## PRODUCT/PROCESS CHANGE NOTICE (PCN)

PCN #: <b>L-0607-01</b>	DATE: <b>4-Aug-2006</b>	MEANS OF DISTINGUISHING CHANGED DEVICES:
Product Affected: <b>Please see the attached list of the affected products shipped in tape and reel and in tubes</b>		<input type="checkbox"/> Product Mark <input type="checkbox"/> Back Mark <input checked="" type="checkbox"/> Date Code <input type="checkbox"/> Other
Date Effective: <b>4-Aug-2006</b>		Lot shipments will have Level 1 Moisture Sensitive Label, and with date code "0630".

**PCN Type:** Change in Moisture Sensitivity Level

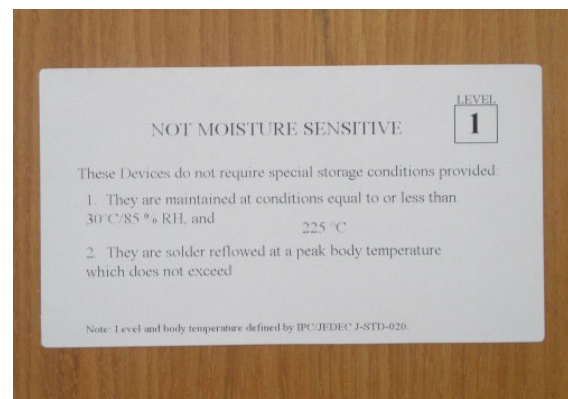
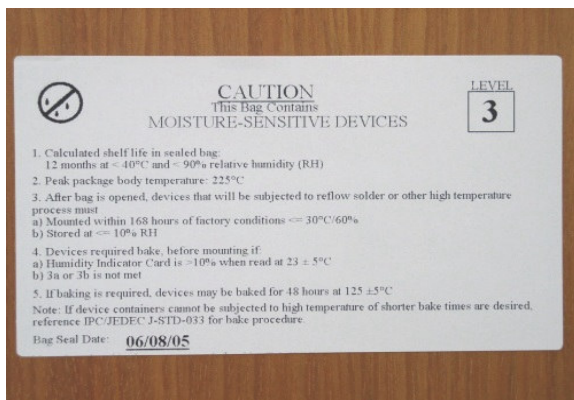
This notification is to advise customers that IDT is converting ICS MSL 3 products shipped in tape and reel, and in tubes, to MSL 1. IDT has completed the verification of the moisture sensitivity classification of ICS products to MSL 1.

The affected products will be shipped without dry pack and labelled as MSL 1 according the JEDEC J-STD-033. There is no change to the assembly material set and the peak reflow temperature. Please refer below for the examples of moisture sensitive labels.

**From: MSL 3 Moisture Sensitive Label**

**To: MSL 1 Non-Moisture Label**

**Note: There is no change to the peak reflow temperature of the affected products.**
